**SAN DIEGO GAS & ELECTRIC COMPANY  
SOUTHERN CALIFORNIA GAS COMPANY  
PIPELINE SAFETY & RELIABILITY PROJECT (PSRP)  
(A.15-09-013)**

**(7<sup>th</sup> DATA REQUEST FROM SOUTHERN CALIFORNIA GENERATION COALITION)**

**Date Requested: October 12, 2016  
Date Responded: October 28, 2016**

**QUESTION 7.3:**

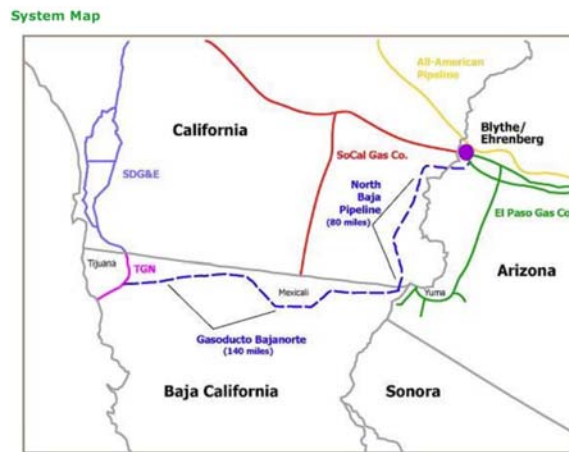
With respect to the Applicants' response to SCGC-06, Q.6.1.2, which describes Gasoducto Rosarito:

- 7.3.1. Please confirm that the Applicants' response to Q.6.1.2 states: "The main pipeline is a 30-inch in diameter pipe capable of transporting 500 million cubic feet of gas per day begins with the interconnection with El Paso Natural Gas Co. near Ehrenberg, Arizona, crosses the border at Los Algodones, B.C., and ends at the interconnection with Transportadora de Gas Natural de Baja California (TGN), south of Tijuana."
- 7.3.2. Please confirm that the Applicants' response to SCGC-05, Q.5.16.3, provided a link to the following map, which appears to show that North Baja Pipeline is interconnected with El Paso Natural Gas Company at Ehrenberg, Arizona:

- 7.3.3. To the best of the Applicants' knowledge is IEnova, the parent company of Gasoducto Rosarito, the owner of the North Baja Pipeline?
- 7.3.4. To the best of the Applicants' knowledge, does Gasoducto Rosarito operate the North Baja Pipeline?
- 7.3.5. To the best of the Applicants' knowledge, does Gasoducto Rosarito interconnect with North Baja Pipeline at the U.S./Mexico border at Los Algodones, B.C.?

7.3.1. Yes.

7.3.2. Yes.

7.3.3. No.

7.3.4. No.

7.3.5. Yes.

**QUESTION 7.12:**

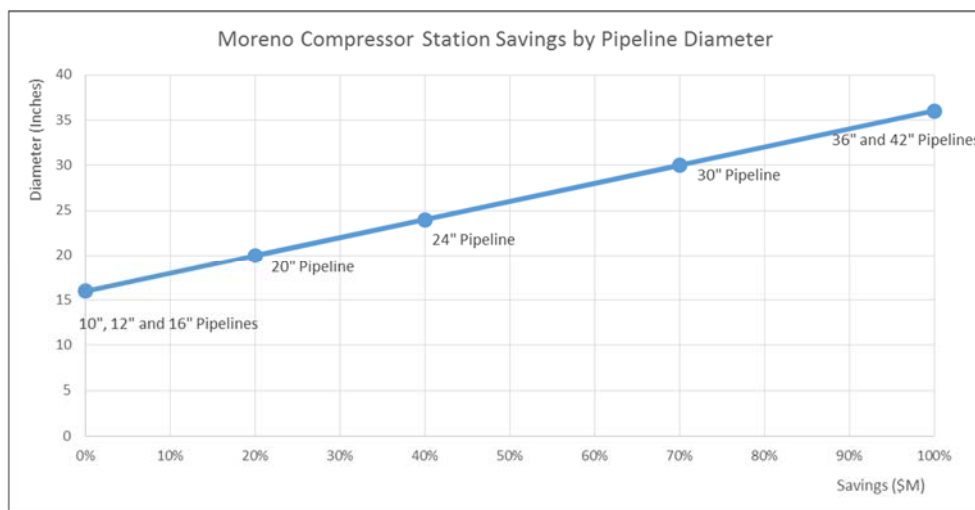
With respect to the Applicants' response to TURN-5, Q.1.a, which has been reproduced here for ease of reference:

7.12.1. The workpaper states: "Cost savings for smaller diameter pipe (20"-30") are factored based on the ratio of pipe diameter to the 36" pipeline - Proposed Project." Please show the derivation of each of the values shown in the chart corresponding to the following pipeline sizes: 10", 12", 16", 20", 24", 30", 36", and 42".

7.12.2. Did the Applicants use their flow model to develop this information?

7.12.1 The figure was developed to show how the Moreno cost savings for the pipeline diameter alternatives (C1-C7) were developed on a factored basis from the detailed savings estimate for the Proposed Project (36" pipeline).

The Applicants estimate approximately \$5.9 million per year in savings based on 95% reduction in operations at the Moreno Compressor Station if a 36-inch diameter gas transmission pipeline is installed, as identified in Table 9 on page 9 of the Moreno Compressor Station Report (See Prepared Direct Testimony of Neil Navin, Attachment A at Attachment XII). It was assumed that no change in Moreno

Compressor Station operations or operating costs would be realized for gas pipelines 16-inches in diameter or less.

To determine the percent savings for the other pipeline diameters, the 0% savings for the 16-inch or less diameter pipelines and the 100% savings (\$5.9 million per year) for the 36-inch pipeline were plotted on a graph. Cost savings for smaller diameter pipe (20"-30") are factored and plotted based on the ratio of the pipe diameter to the 36" pipeline - Proposed Project.

The percent savings for the remaining alternative diameter pipelines were plotted on the graph. The resulting graph shows the estimated proportional savings on a percentage basis for the different diameter pipelines relative to the Proposed Project (36" pipeline).

7.12.2 No.
